TELEDYNE CONTINENTAL[®] AIRCRAFT ENGINE

SIL 00-11A

SUBJECT: RELEASE OF NEW CYLINDER INDUCTION PORT DRAIN CONNECTOR

FIGURE 1
Cylinder Induction Port Fuel Drain Fittings

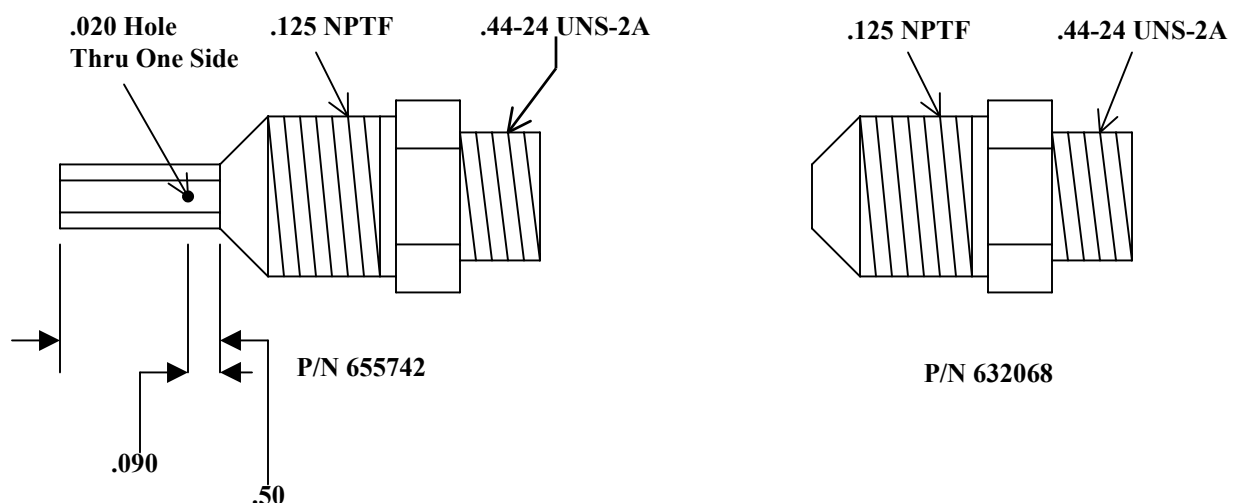
PURPOSE: To Notify Owners, Operators and FBO's of the availability of P/N 655742 Cylinder Induction Port Drain Connector, Replacing Drain Connector P/N 632068, To Enhance Cold Weather Engine Starting Characteristics.

To install the P/N 655742 drain connectors:

1. Sparingly coat the male threads of drain connector P/N 655742 with TCM P/N 646940 (Loctite 569) sealant.
2. Install the drain connector P/N 655742 into the tapped hole in the bottom of each cylinder induction port. Torque the drain connector to 60 – 80 inch lbs. Repeat the procedure for each cylinder.
